# CITY OF MURFREESBORO PLANNING COMMISSION AGENDA

June 22, 2016  
1:00 PM

**MURFREESBORO PLANNING COMMISSION  
STAFF COMMENTS, PAGE 1  
JUNE 22, 2016**

**MASTER PLAN**  
**MUIRWOOD S/D**  
**SECTION V**  
12th CIVIL DISTRICT - RUTHERFORD COUNTY - TN.  
DATE: MAY, 2016 SCALE 1"=100' SH. 1 OF 6

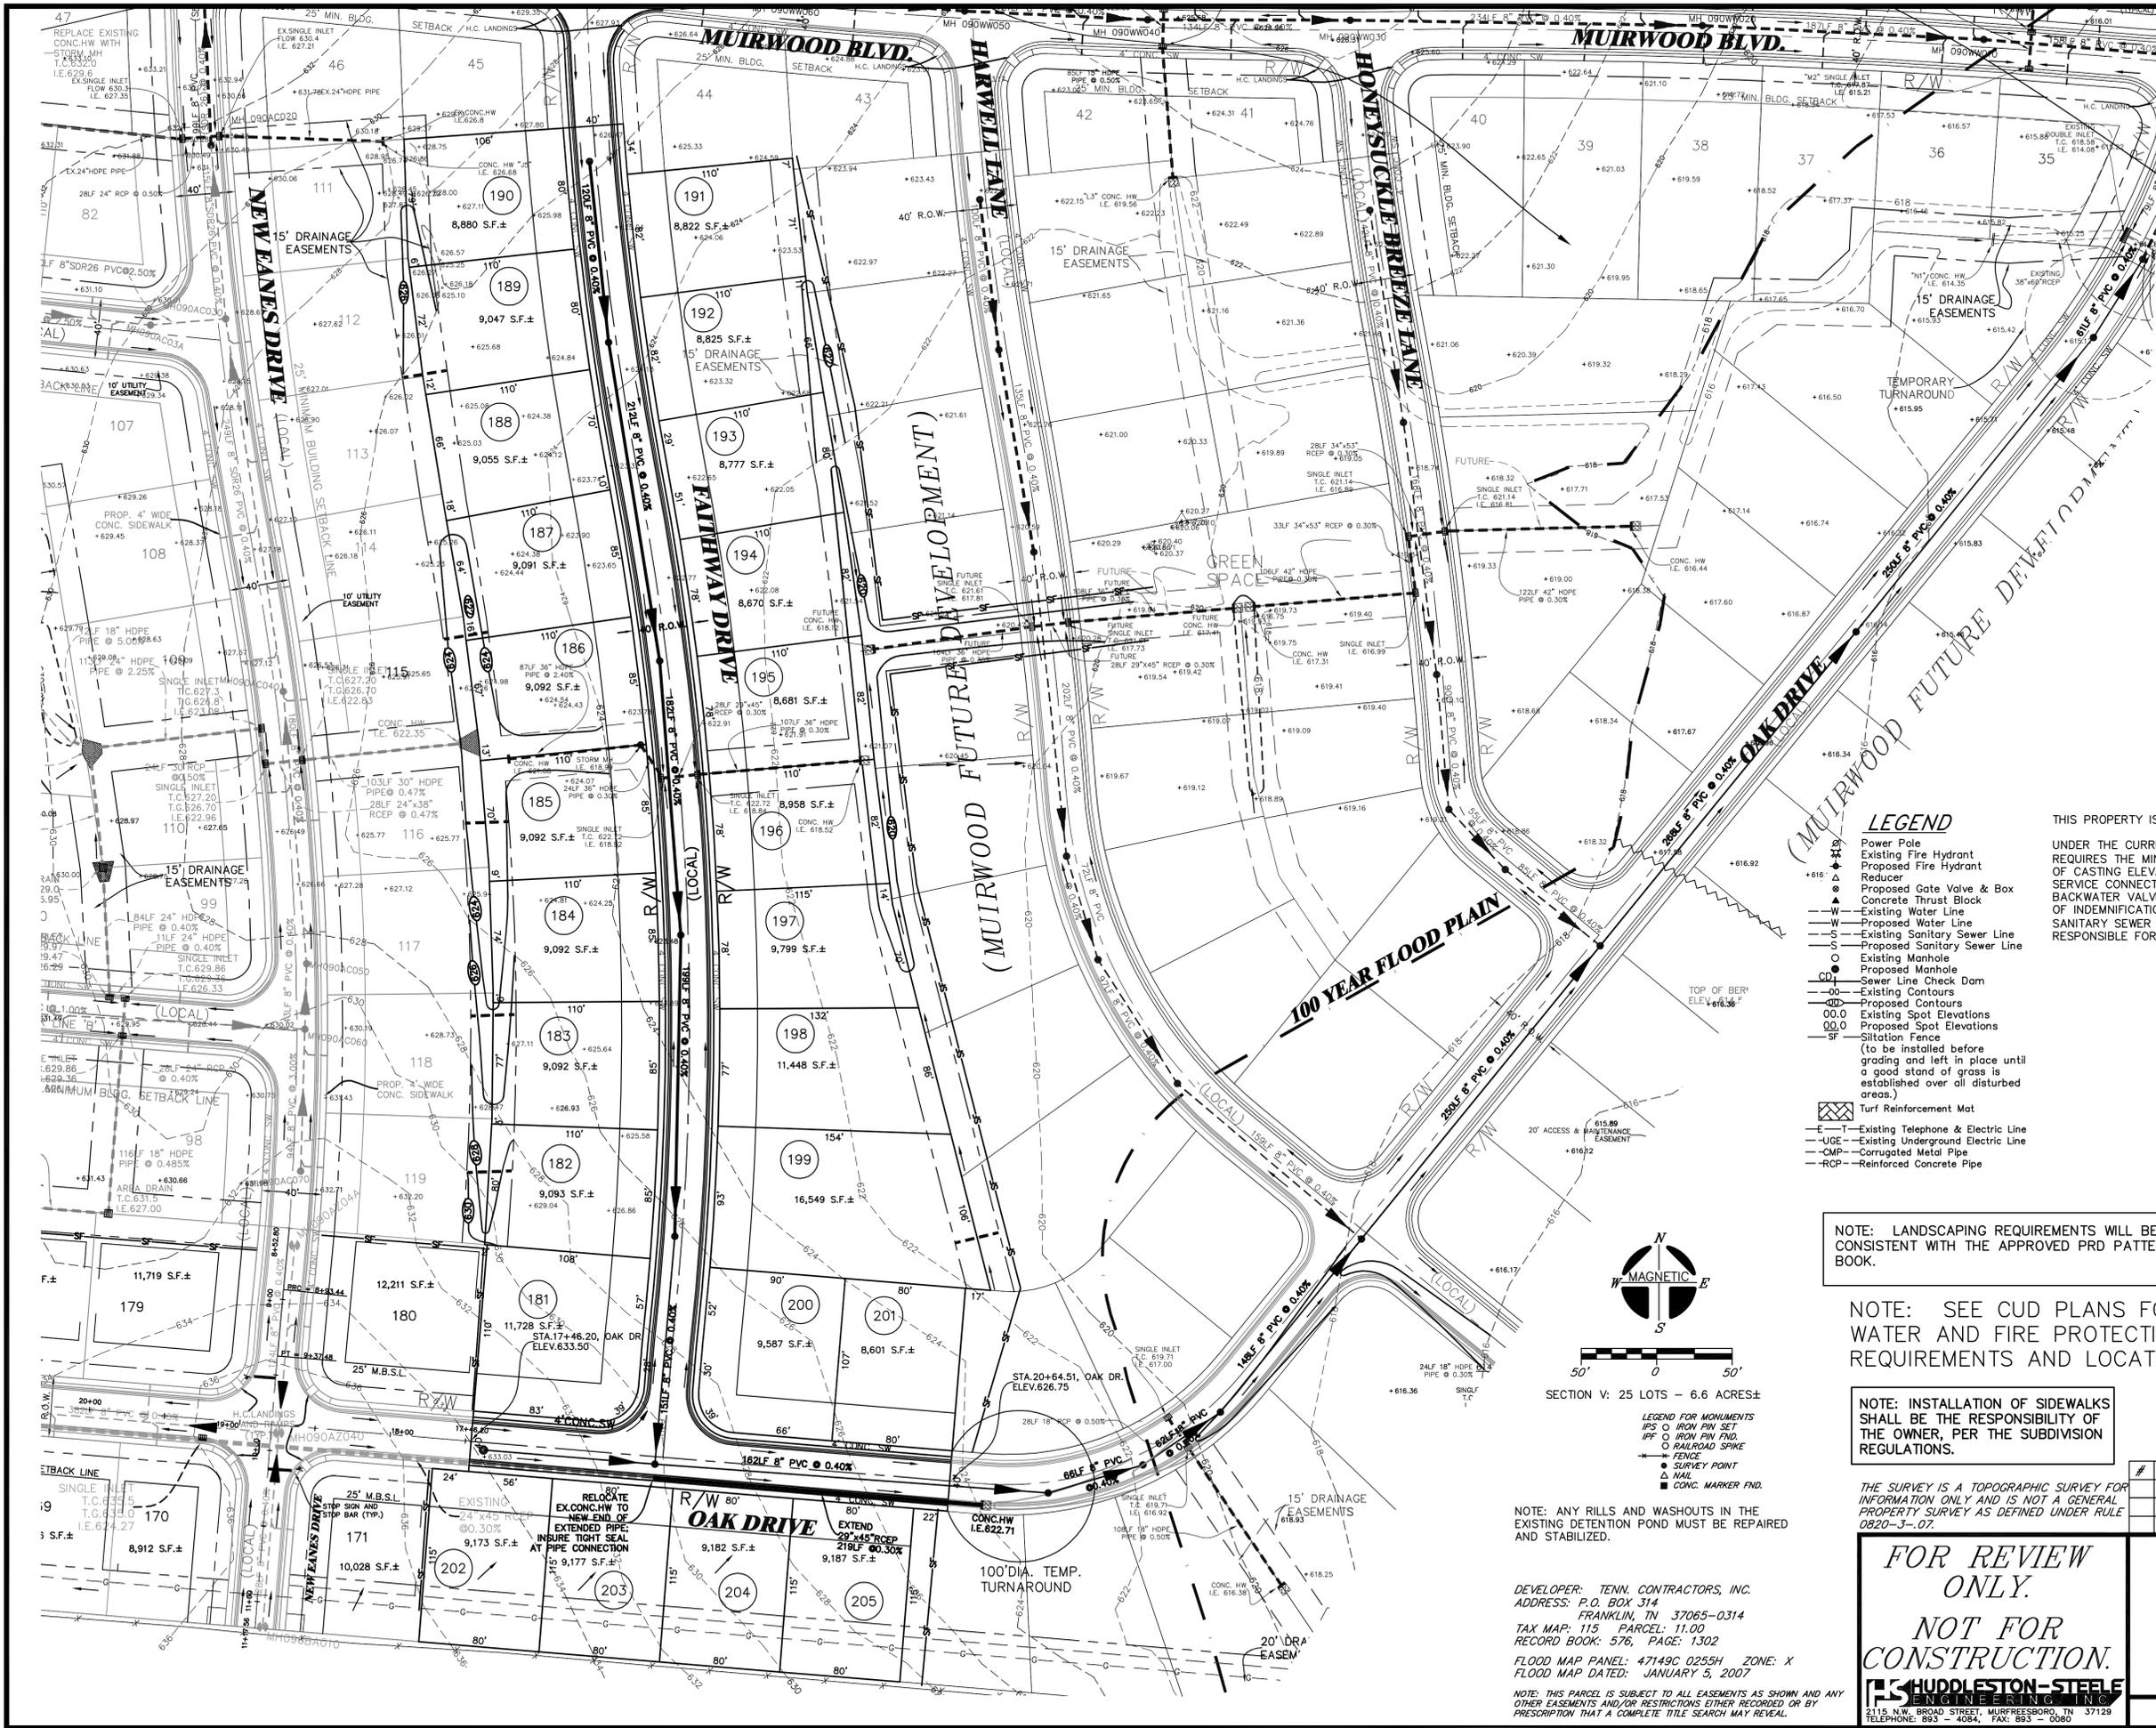
- 1) Revise the note regarding the installation of sidewalks to be the responsibility of the builder, not the owner.
- 2) Show the traffic control elements on the preliminary plat and on the construction plans.
- 3) The Engineering Department point of contact for this project is Katie Noel (615-893-6441 or KNoel@MurfreesboroTN.gov).
- 4) Add handicap ramps at intersections.
- 5) Add street name signs and stop signs at intersections.
- 6) All grading on lots should be complete prior to signing the final plat and the release of building permits.
- 7) A PDF version of the plans must be submitted to Planning Staff upon receipt of these comments for the Planning Commission's review and must be submitted in conjunction with any future re-submittals.

**REVIEW SHEET**  
 (Not intended for construction)

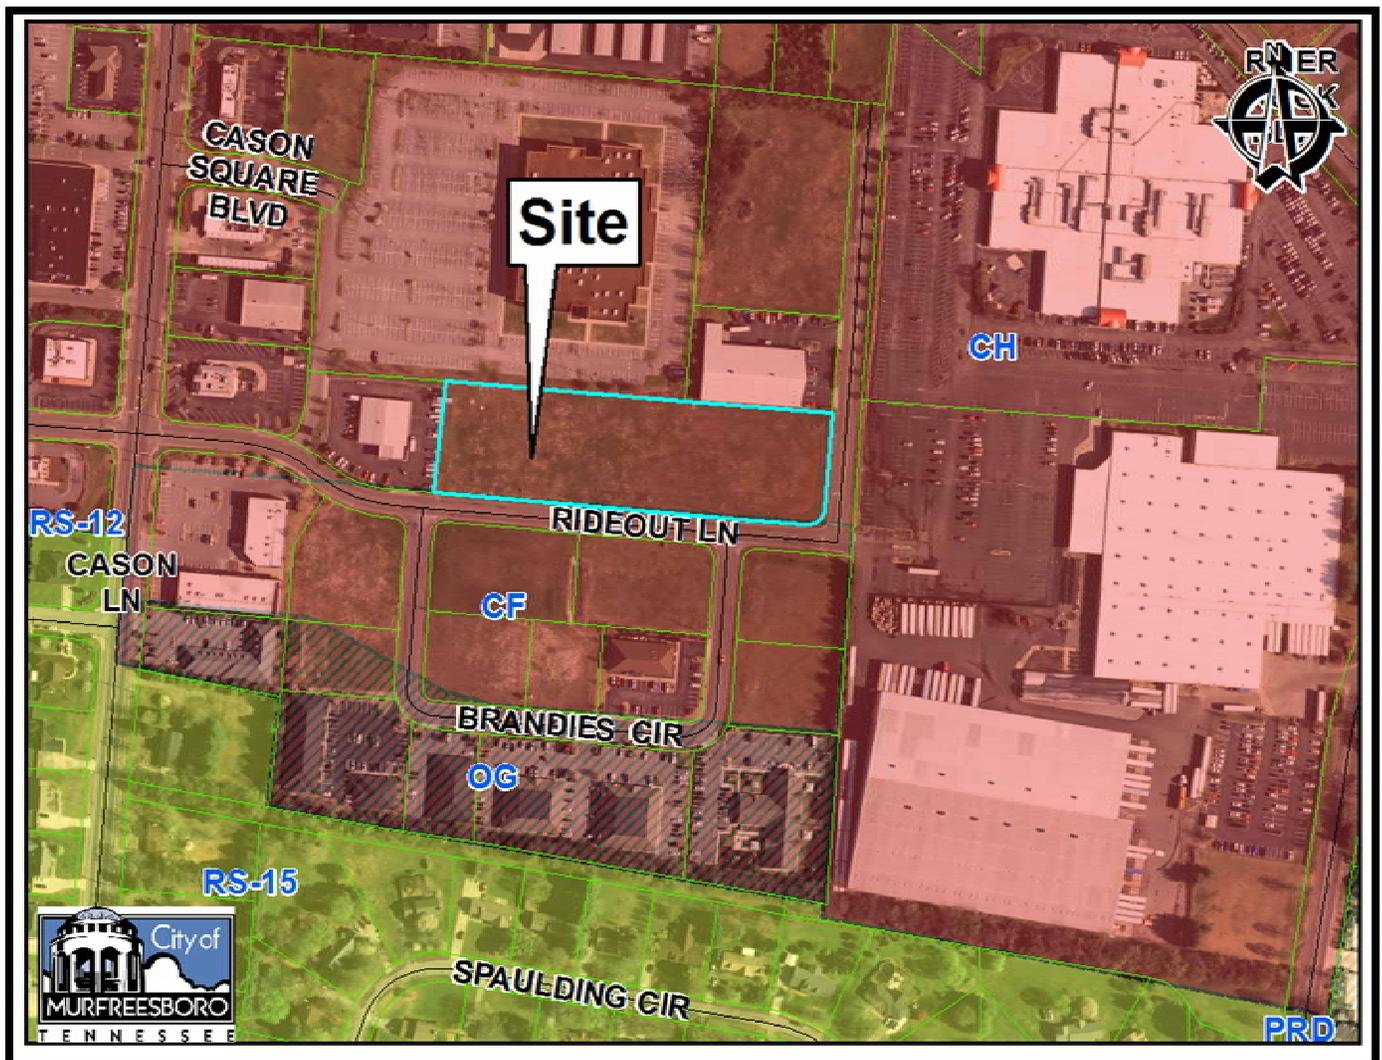
- 1) Provide E-911 approved street names for the two unnamed streets on the preliminary plat, including a new street name for the
- 2) In the site data table, the 15,000 square-foot minimum lot size is incorrect. Please correct.

- 3) Per the Subdivision Regulations, the minimum lot width at the ROW line must be 40'ft. Revise lot 85 so that it meets this requirement.
- 4) Confirm that the builder has a house plan that will fit Lot 85. Add a note that a surveyor will be required to lay out the footing for Lot 85.

- 7) Provide necessary stop signs and street name signs at all intersections.
- 8) Provide drainage structure and pipe tables.
- 9) Provide an outlet to the detention pond and provide details.

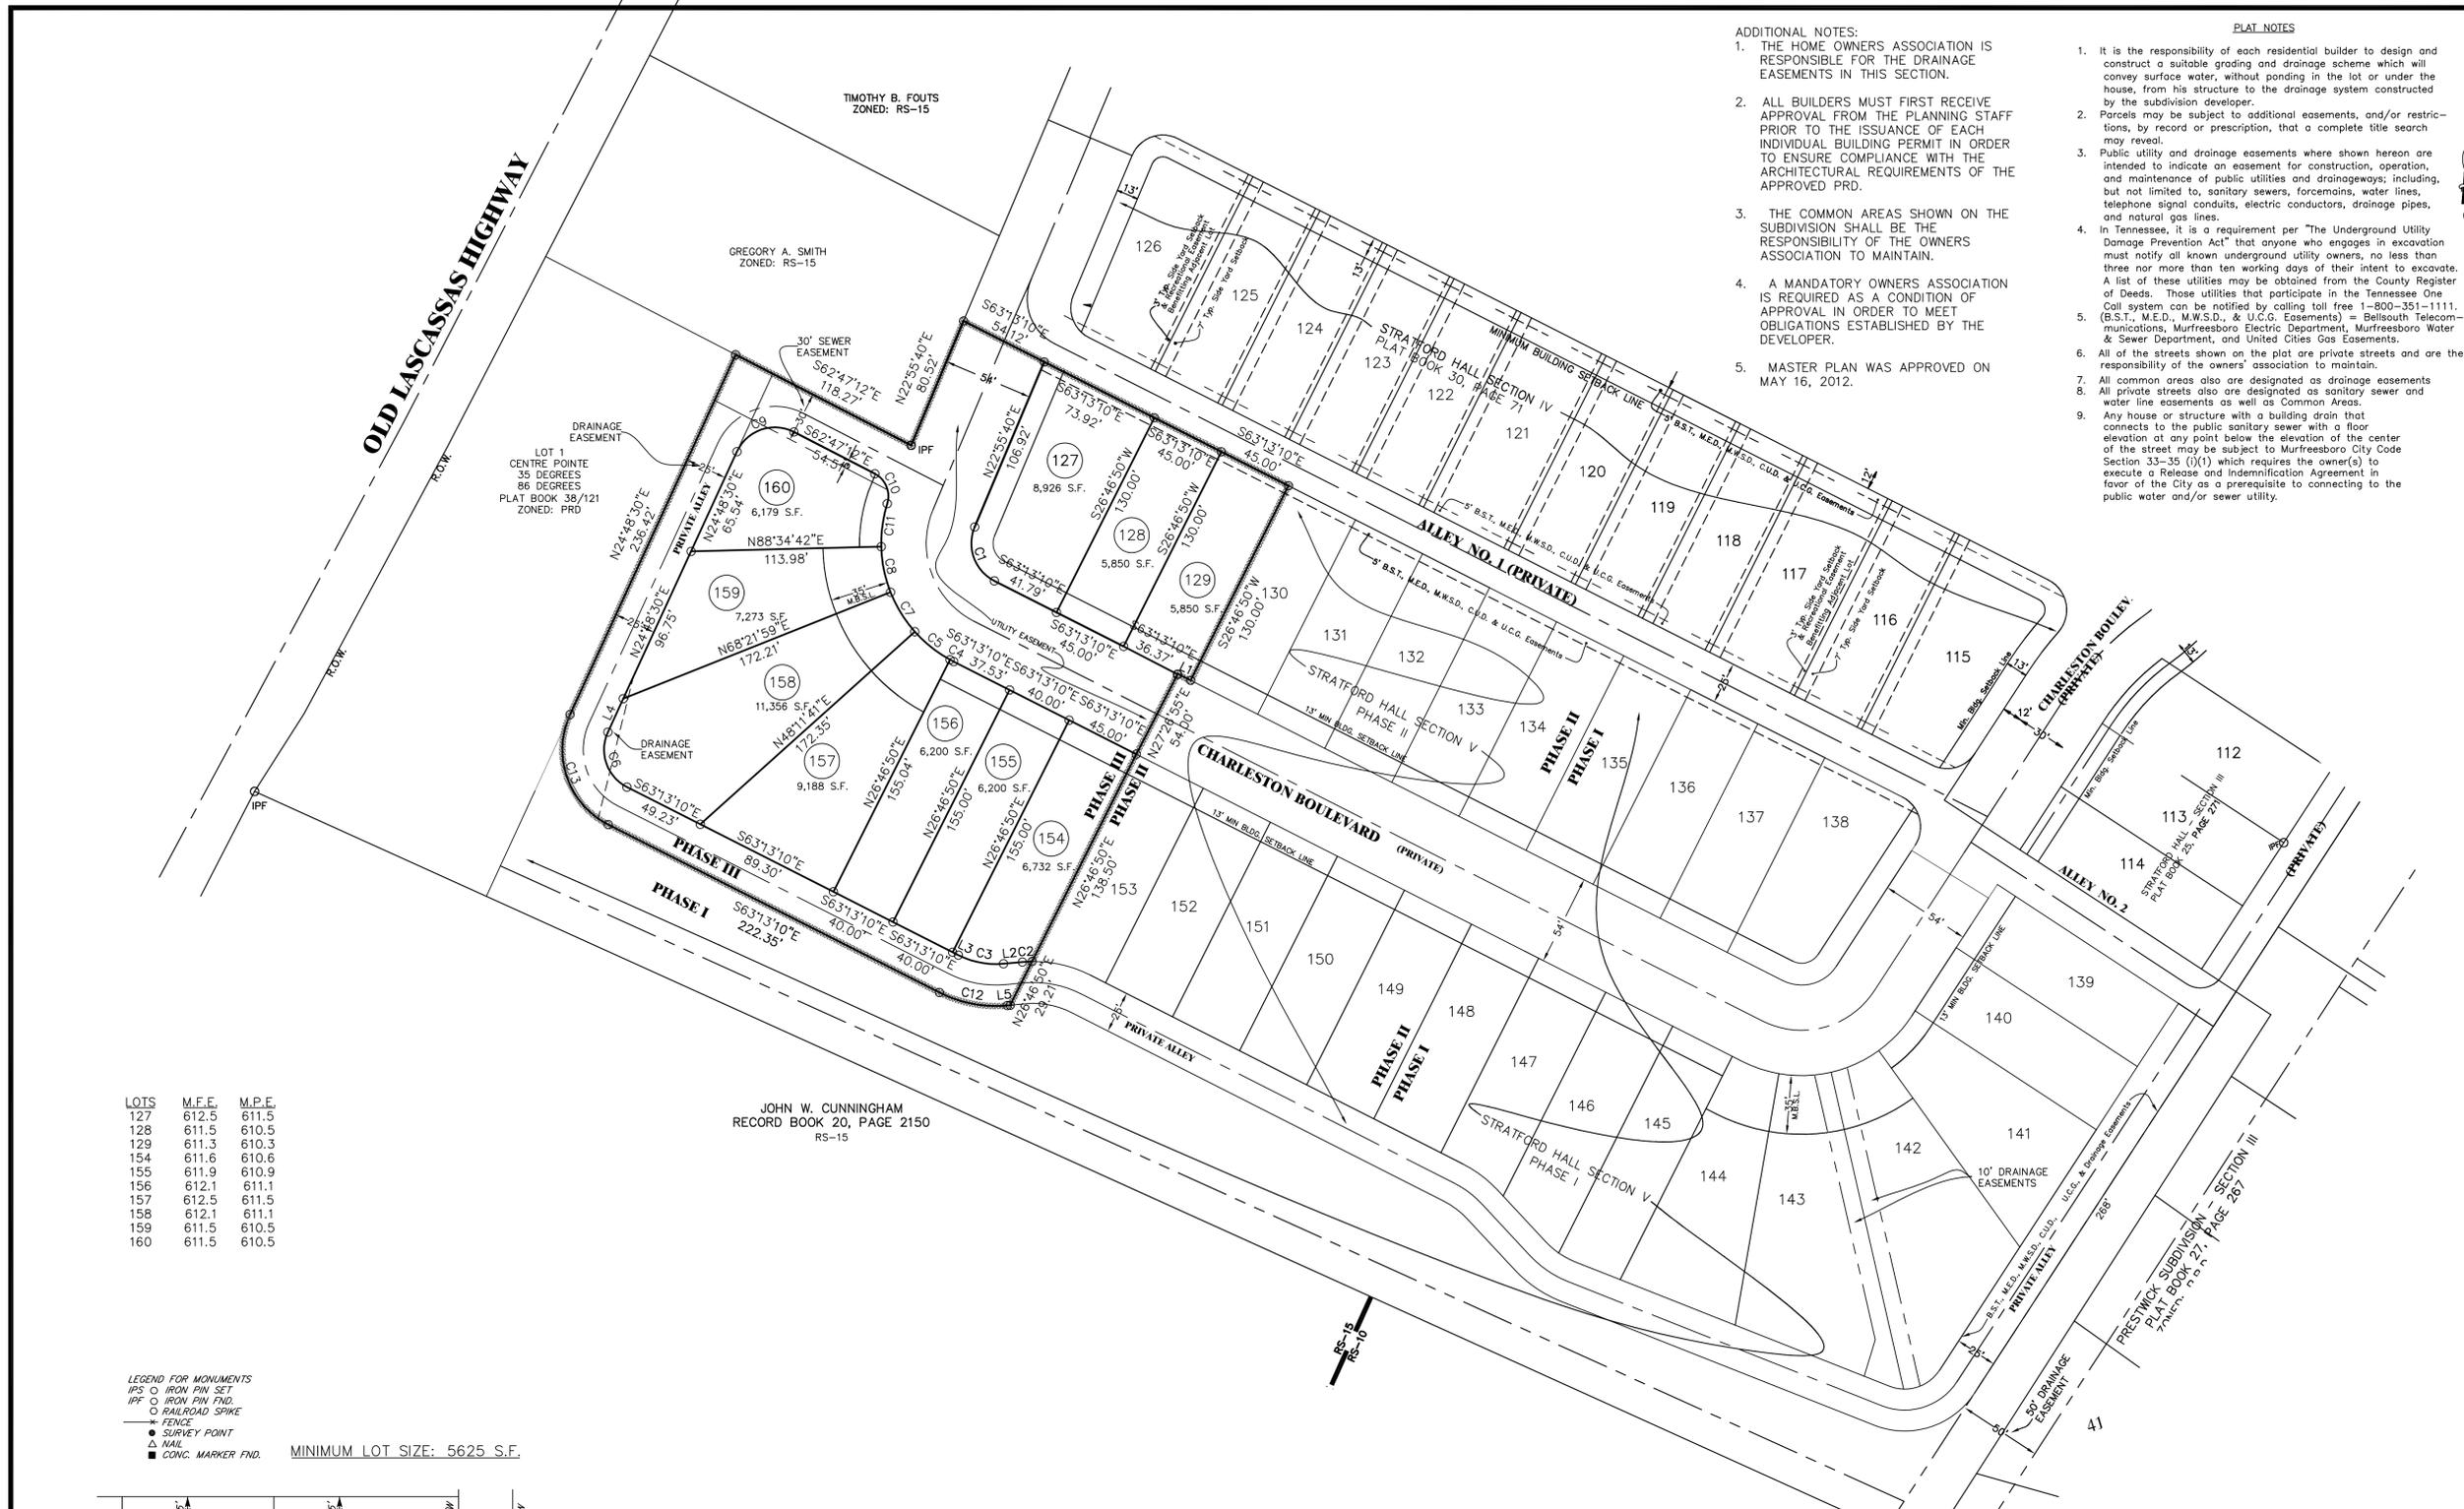
- 1) Old Lascassas Highway should be relabeled as Old Lascassas Road.
- 2) Provide a more legible location map. In addition, on the location map, Old Lascassas Pike should be Old Lascassas Road and New Lascassas Road should be Lascassas Pike.
